20TH. FLOOR FRAMING PLAN.			
7 WORLD TRADE CENTER.			
TISHMAN CONSTRUCTION.	CUSTOMER		
EMERY ROTH & SONS P.C.	ARCHITECT		
IRWIN G. CANTOR P.C.	ENGINEER

SQUAD F.R. | MADE BY: GP | DATE | CHKD. BY Jim | DATE | APPD.
CONT. No. 84-15 | SHEET E20

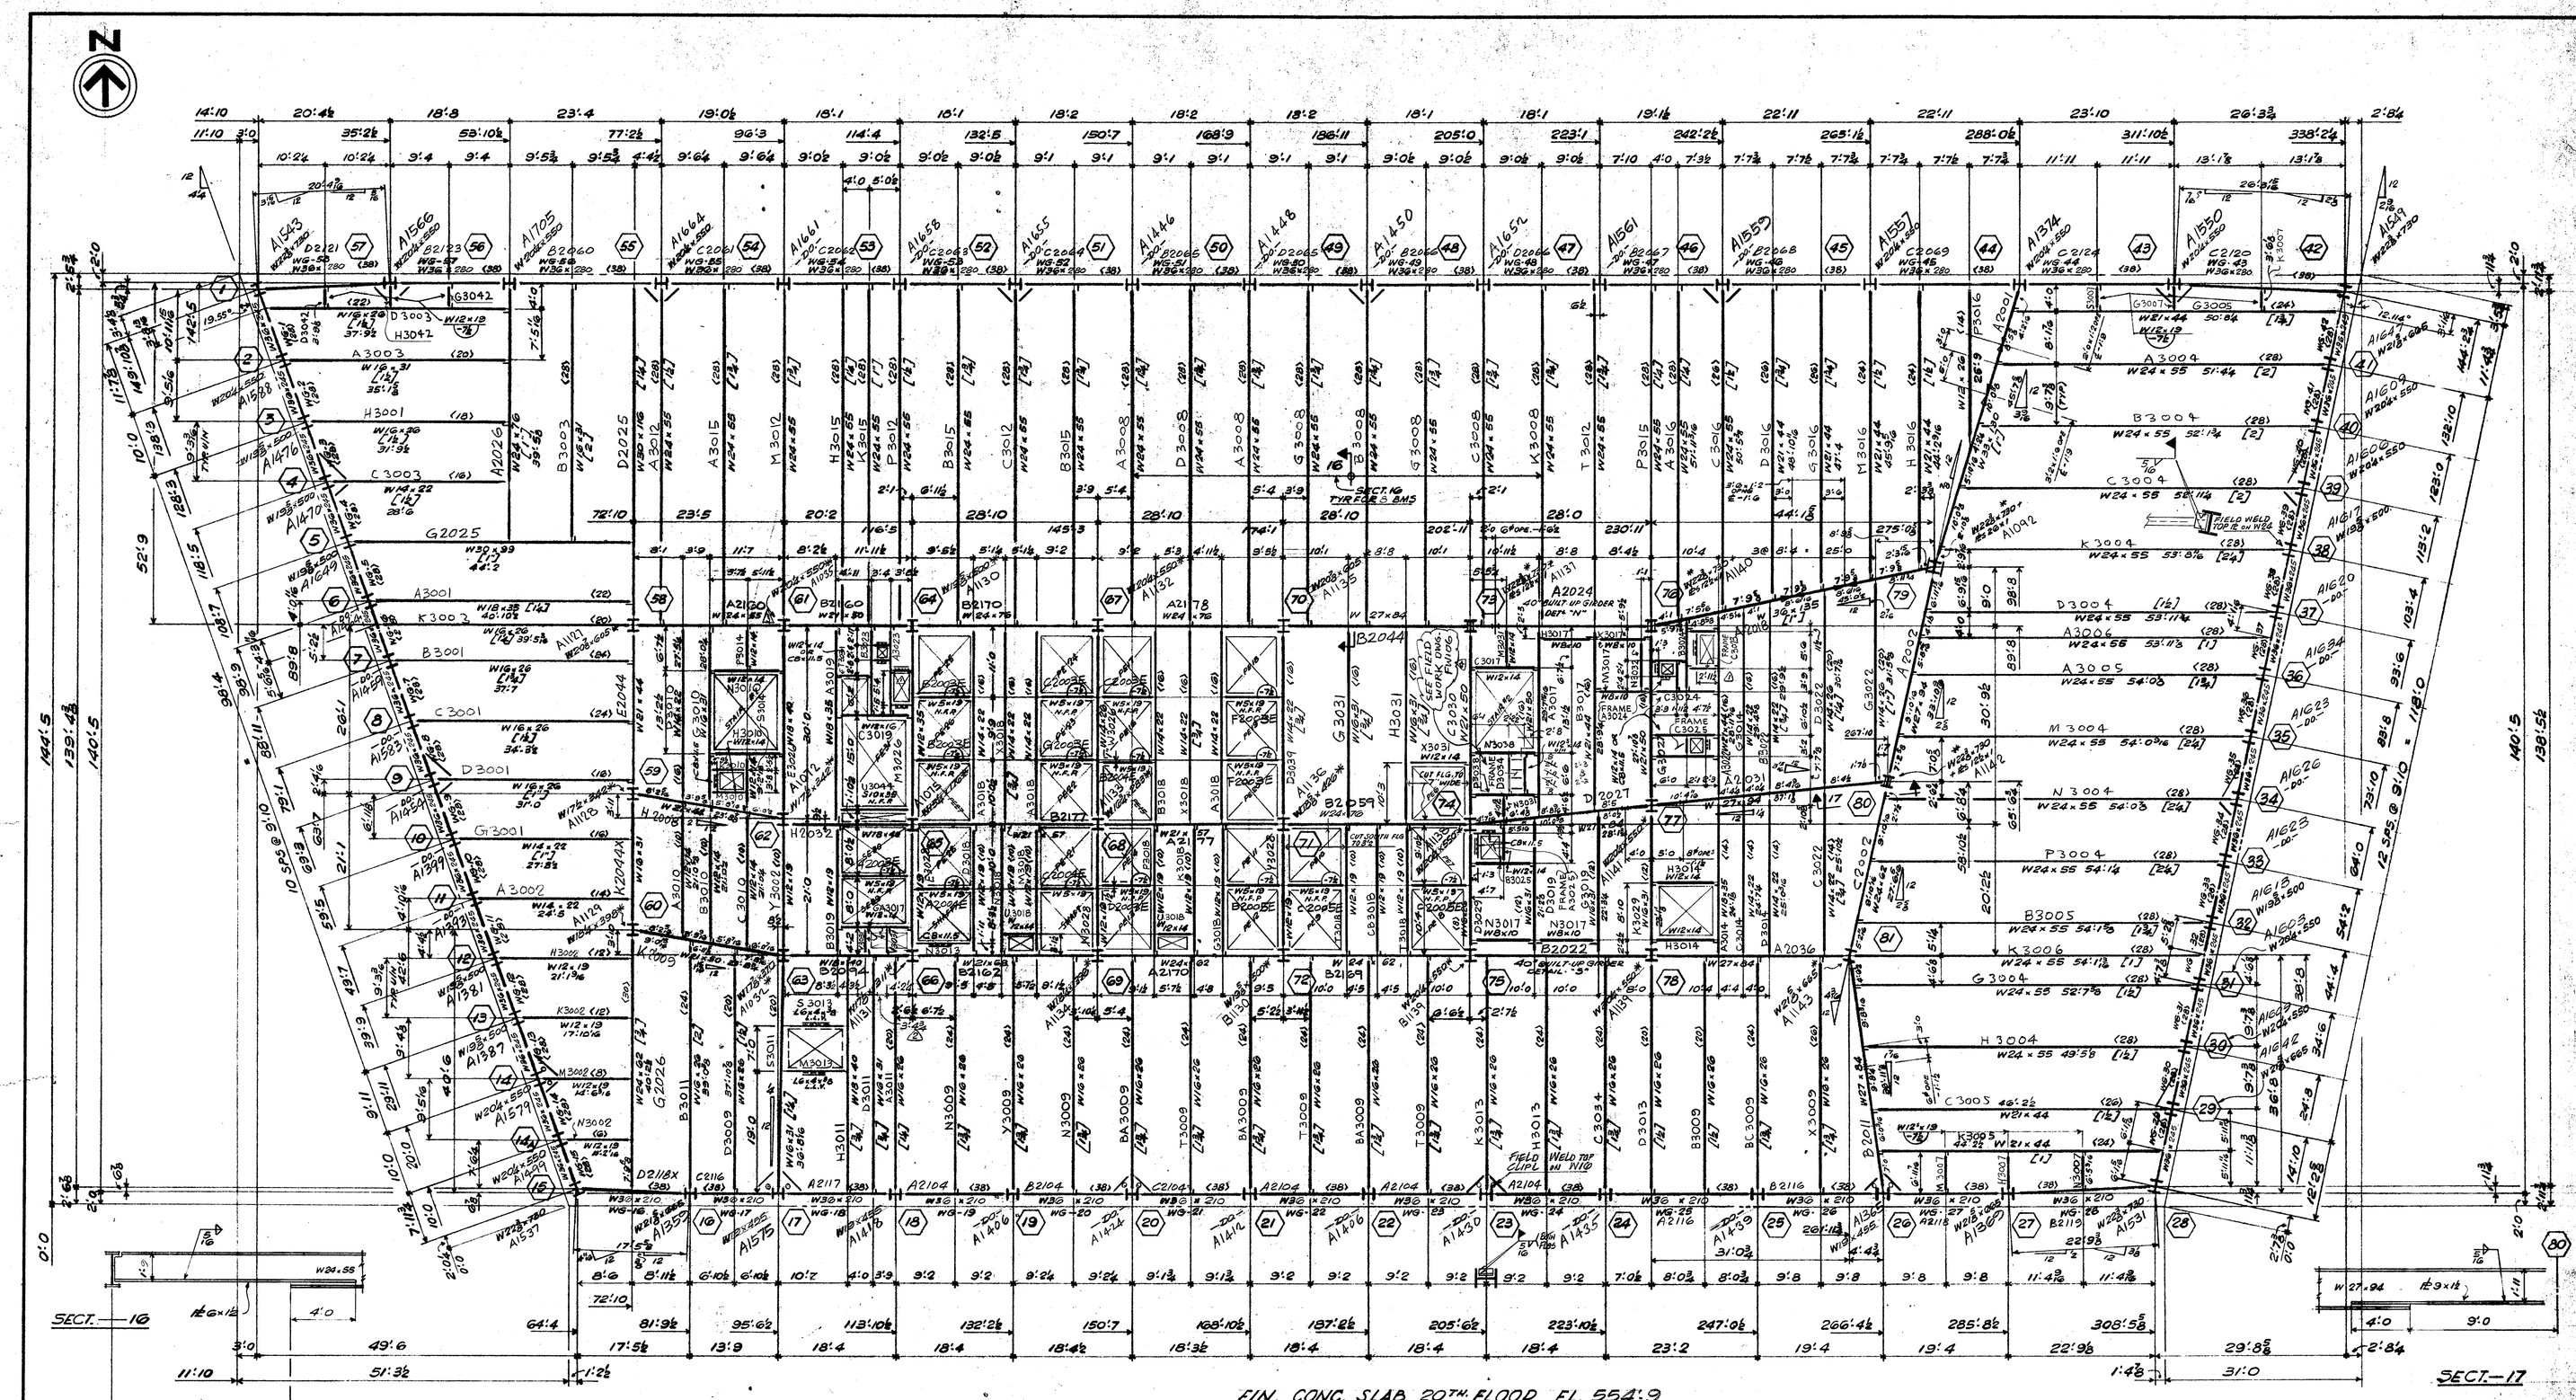
NO.	DATE	BY	REVISION.
5	Nov. 12/85	BF	NOTE FOR ADD. STUDS (X54)
4	Nov 6	SF	FW10G - ADDED
3	MAY 26	JIM	OPENING, KICKER & BM STIFN.
2	5/23/85	GP	X26 OPEN'G @ COLGG REV.
			ELEC'L CLOSET 'C' REV 3/21/85.
1	04/9/85	GP	TO APPROVAL 04/17/85
